## SB, Missing alignment hole in straight shaft tube, Edger Accessory Attachment, 2020-11

Figure 1:

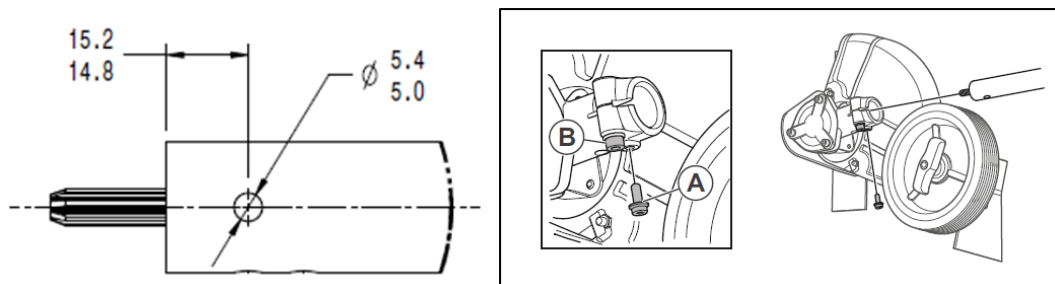
Some products were shipped missing the pre-drilled alignment hole that the tube uses as an aid for aligning and constraining the edger head in the proper location. If the tube assembly was provided without this pre-drilled hole, a replacement tube assembly may be needed for correction.

Note: As indicated in figure 2, this set hole is in line with the rectangle slot in the opposite end. Also, note, there are 2 holes in line from each other, rotated 90° from this expected position.

Product sold to end user	Residual inventory not yet sold
What is required:	Service is required.	Inspection is required.
When to do:	Only if encountered.	At pre-delivery inspection.
What to do:	Follow instructions below when encountered.	
How to do:	Order a replacement tube assembly and replace.
